TRANS/WP.29/2001/31  
12 April 2001

World Forum for Harmonization of Vehicle Regulations (WP.29)  
(One-hundred-and-twenty-fourth session,  
26-29 June 2001, agenda item 4.2.16.)

PROPOSAL FOR DRAFT SUPPLEMENT 1 TO REGULATION No. 100

(Battery electric vehicles)

Figure 7.1  
Determination of hydrogen emissions  
during the charge procedures of the traction battery.

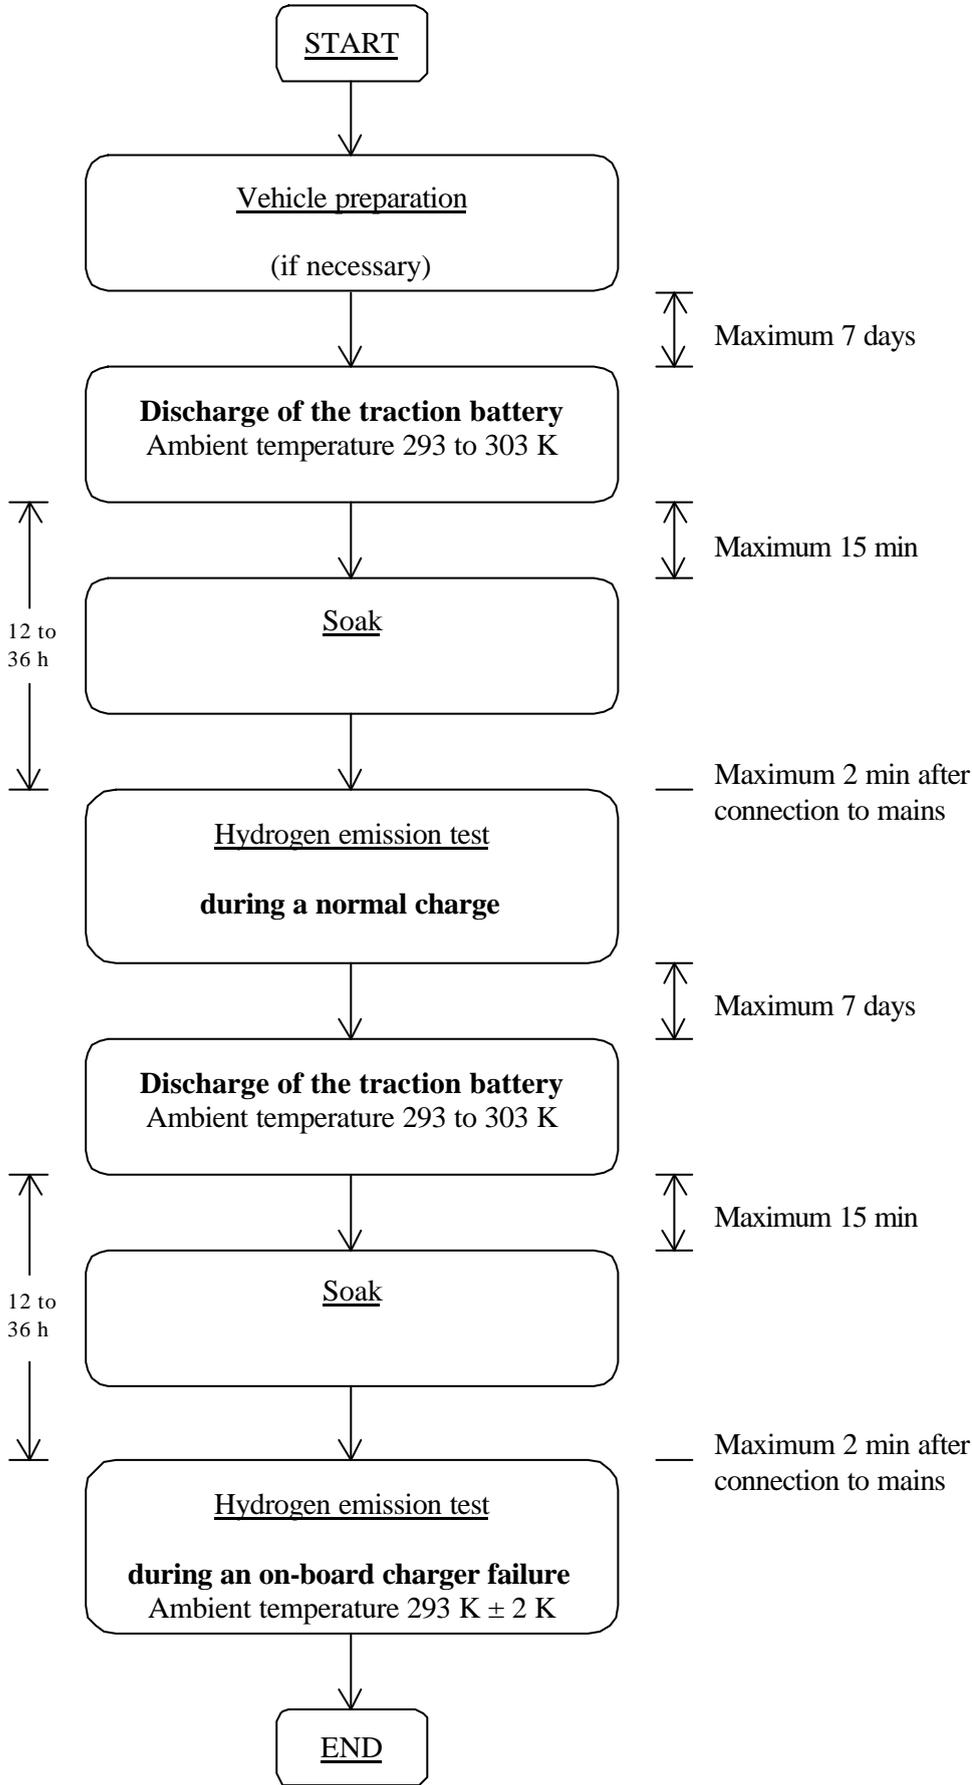
The hydrogen emission test (Figure 7.1) is conducted in order to determine hydrogen emissions during the charge procedures of the traction battery with the on-board charger. The test consists in the following steps:

- (a) vehicle preparation,
- (b) discharge of the traction battery,
- (c) determination of hydrogen emissions during a normal charge,
- (d) determination of hydrogen emissions during a charge carried out with the on-board charger failure.
